**Re: 4001 West Mercer Short Plat
SUB21-002**

Please consider this as a written response to the City of Mercer Island first review comments dated September 14, 2021.

RE: Request for Information #1 for File No. SUB21-002 – Angiuli Pacific Res Trust Short Subdivision 4001 West Mercer Way, Mercer Island, WA 98040; King County Tax Parcel # 362350-0365

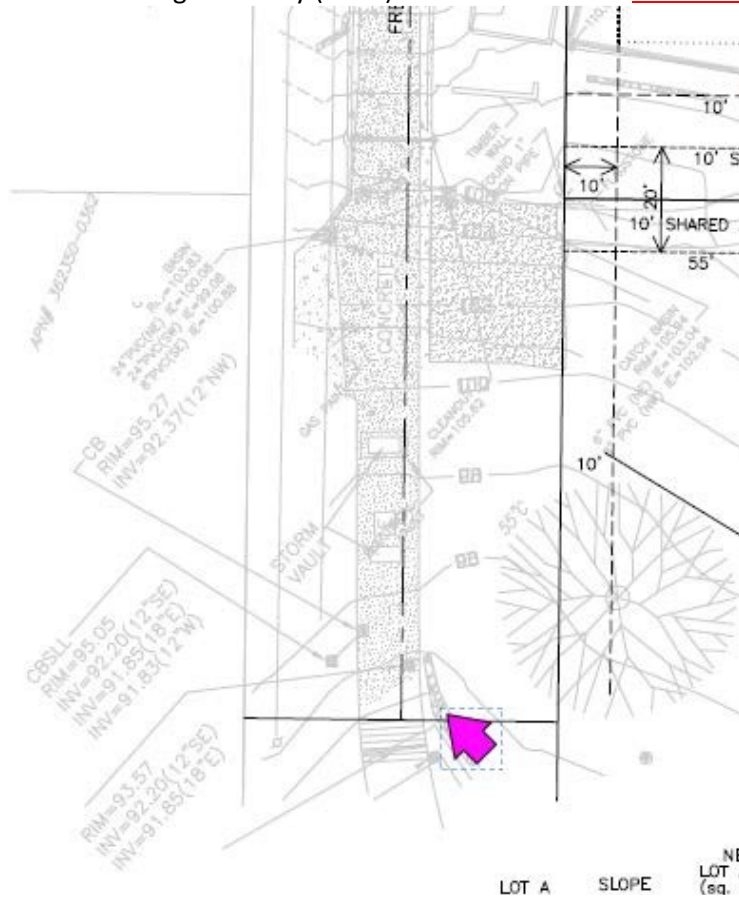
- e. Please note lot area and net lot area. Net lot area is the area contained within the established boundaries of a lot, less any area used for public or private vehicular access easements, excluding that portion of the easement used for a driveway access to the encumbered lot. The minimum **net**

lot area for the R-15 zone is 15,000 square feet. For Lot A, the portion of the access easement used to access the future house on Lot A can be a maximum of 342sf since the current proposed lot area for Lot A is 15,342sf. When measuring the proposed shared access easement area on Lot A using the provided scale it came out to ~885sf. **The Development Plan Set, Site Plan, Sheet 6 of 9 has been updated to include 4007 West Mercer and the required net areas.**
